**From:** [kevin.Crosland](#)  
**To:** [IPCN Enquiries Mailbox](#)  
**Subject:** Mirvac Harbourside development  
**Date:** Tuesday, 27 May 2025 5:06:42 PM  
**Attachments:** [Screen Shot 2025-05-20 at 5.53.14 pm.png](#)

**NORTHERN PODIUM:**

**Figure 5 | Harbourside Concept Approval building envelope layout (Base source: SSD 7874 MOD 4)**

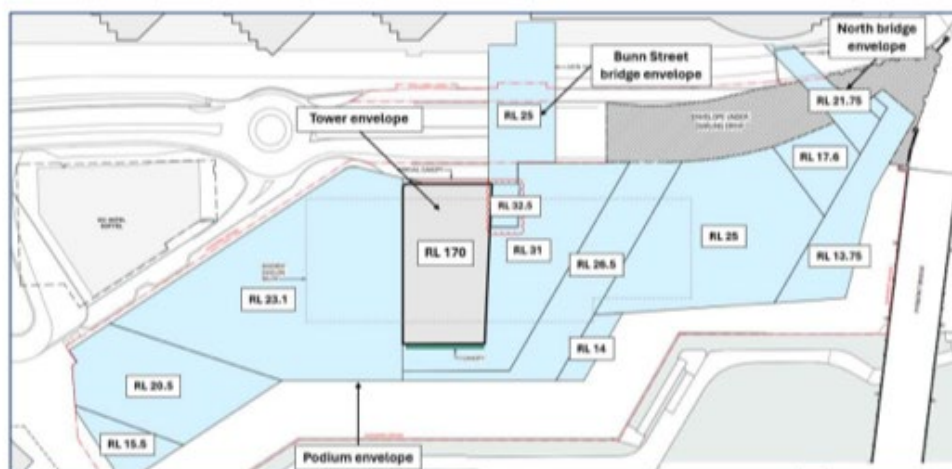
Firstly, The height limit was written as RL12.5.

The plan below shows many different in excess of this height limit (some minor and some drastic over height).

There is to be some small amount of soil mounding for trees and landscaping, but all areas are in excess of the granted RL12.5
